**Re: 0 Banfield Road – Chinburg Subdivision – Response to TAC Comments**

*2-4-2025 Staff TAC Comments*

**0 Banfield Road (LU-25-22)**

SUBDIVISION PLAN  
TAX MAP 255 - LOT 2

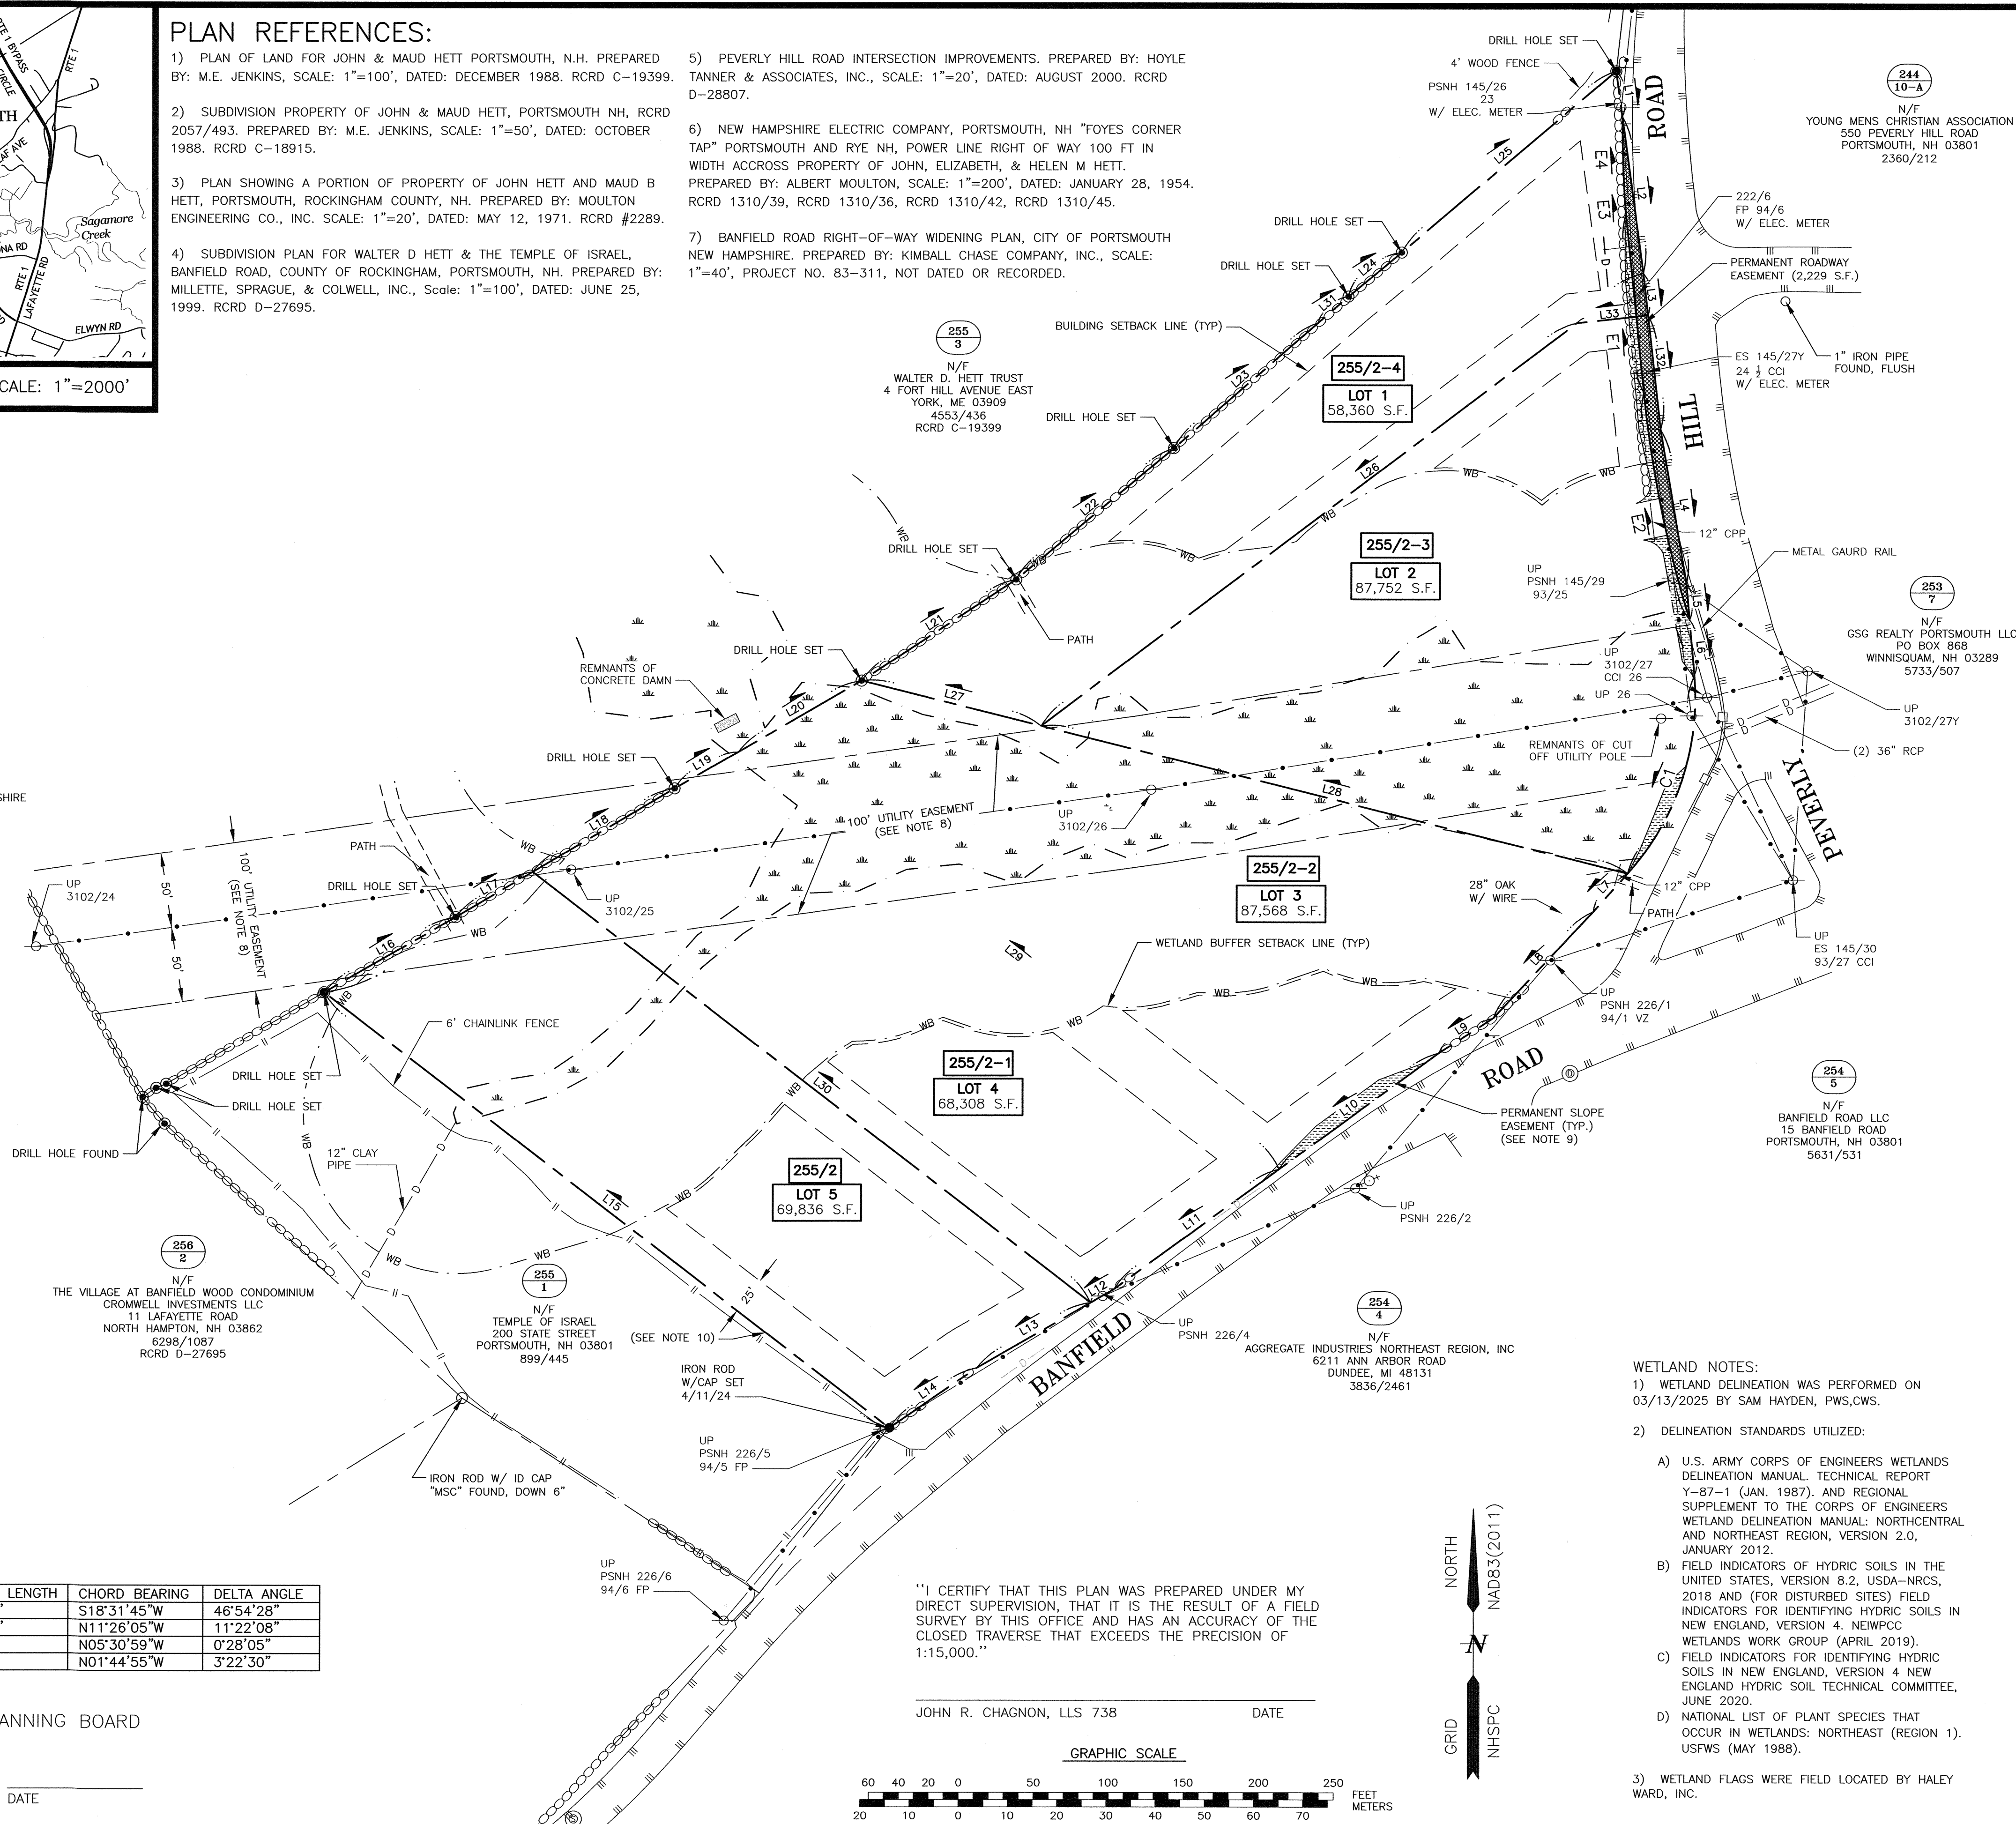
3. *Proposed Lot 1 does not provide the required frontage (150').*  
The attached plans show the proper frontage for all the Lots.
4. *Please correct the subdivision checklist to include sheet numbers.*  
The subdivision checklist will be finalized when we complete the application process, after further TAC review.

5. *Please include the delineation for the wetland across the street on Map 254 Lot 4 and the associated 100' buffer and CWS stamp.*

The wetlands across the street are now shown on our plans. Buffer areas associated with these wetlands have also been added.

UTILITY SITE PLAN  
TAX MAP 255 - LOT 2  
OWNER:  
WALTER D. HETT  
BANFIELD ROAD &  
PEVERLY HILL ROAD  
CITY OF PORTSMOUTH  
COUNTY OF ROCKINGHAM  
STATE OF NEW HAMPSHIRE

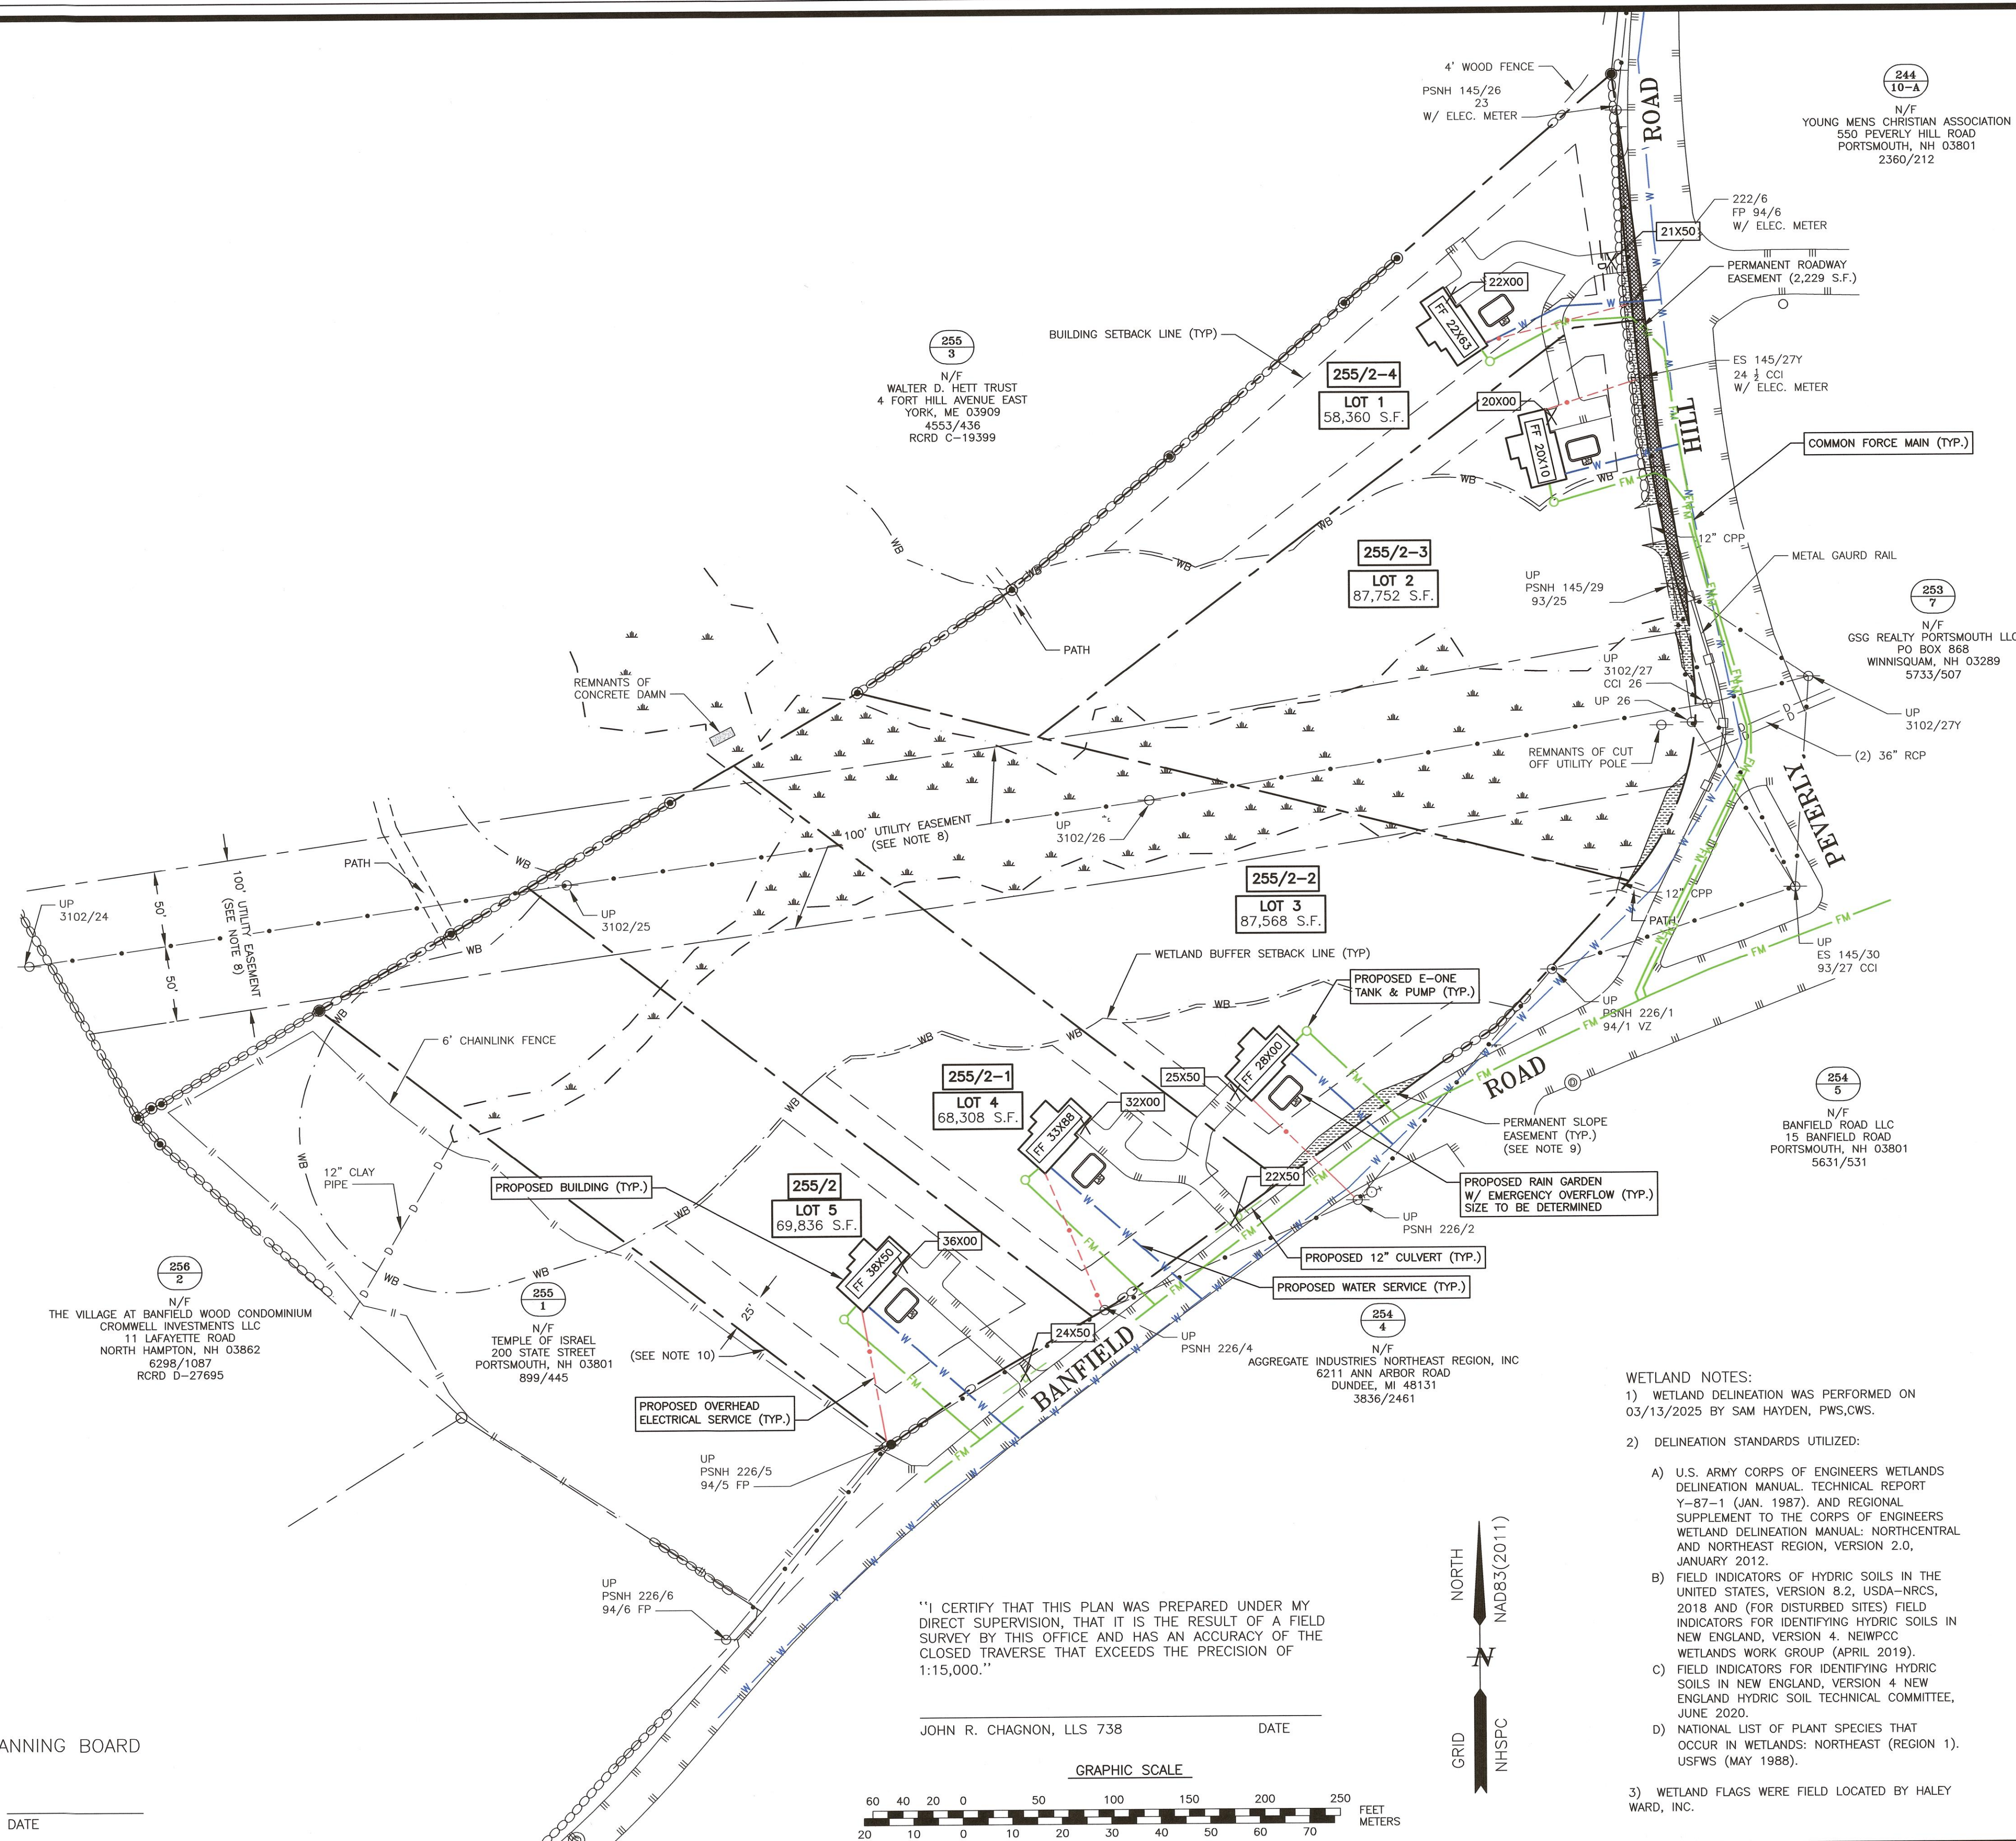
6. *Please show where the proposed force main will connect to City sewer.*

7. *Correct the layout of existing utilities. Location of 20" water main is incorrect and existing force main location is incomplete.*

8. *Lots 1 and 2 show connection to a sewer force main headed north on Peverly Hill Road. No such force main exists. City suggests connecting the sewer services to the sewer force main to the south, or the gravity sewer main in the intersection of Peverly Hill and Mirona Road.*

9. *Lots 1 and 2 share an EOne pump. Each lot needs its own separate pump system.*

10. *EOne pumps do not require septic tanks before pump. Remove septic tanks.*

12. *Electrical transformers at each property may not be necessary. Secondary power may be available directly from overhead wires.*

The proposed forcemain pipe connections are now shown on the attached plans.

We have updated the existing utilities locations on the attached plans.

The utility connections for each lot have been updated based on comments from the March TAC meeting.

The proposed utility connections for each lot have been updated.

The proposed utility connections for each lot have been updated.

We have updated the utility connections for each lot.

#### TYPICAL SANITARY SEWER SERVICE DETAIL

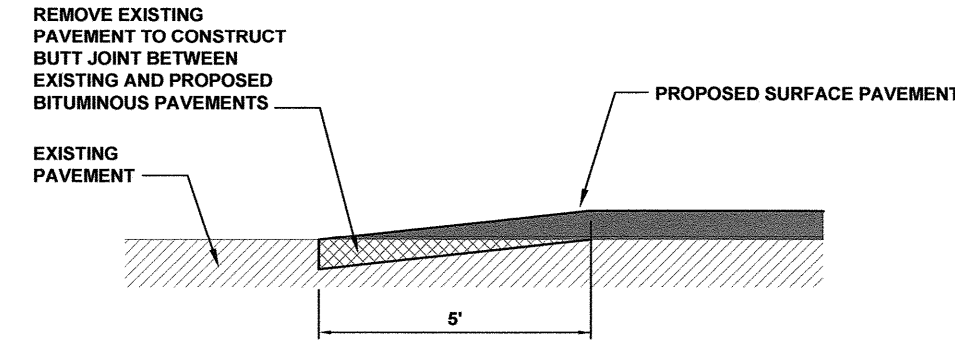
11. *Provide detail on sewer service connection to sewer force main.*

Details have been added to the plans.

#### TYPICAL ASPHALT PAVEMENT GRINDING DETAIL

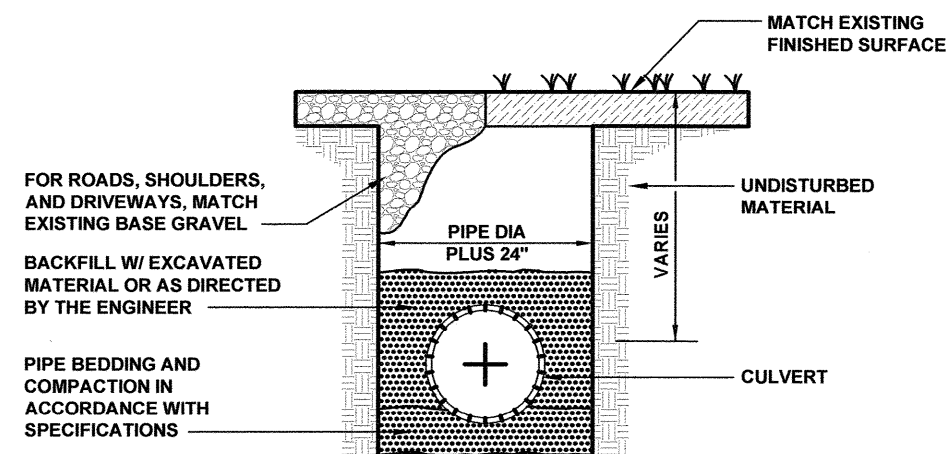
13. *Banfield Road was recently paved. Disturbances in Banfield Road will require full mill and overlay of disturbed area. Provide detail of mill and overlay.*

The limits of the full mill and overlay area has been included on the attached plans.
